Access Compliance Report

Public Rights-of-Way

(Curb Ramps)

Intersection ID: N/A	Main Street: PROVIDENCE_COUNTRY_CLUB_DR	Cross Street: SOUTHMORE_DR	Location: NW
ADA ID: 780D700647E9	Ramp Type: PerpDiag	Initial Pass/Fail: Fail	Overall Compliance: No
Severity Score: 12.5			
Codes/Mitigation Info/Possible Solution		Field Measurements/Component Compliance

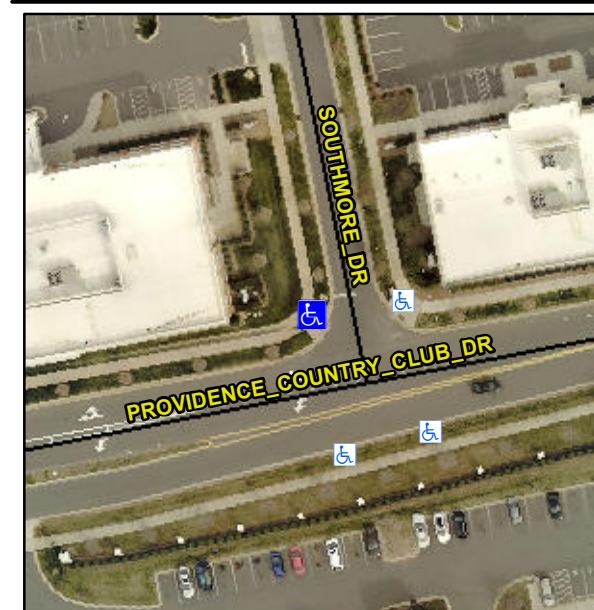
Possible Solutions:

Remove & Replace Curb Ramp With Two New Directional Ramps or Equivalent.

PROW/ADA:

R304.2.2
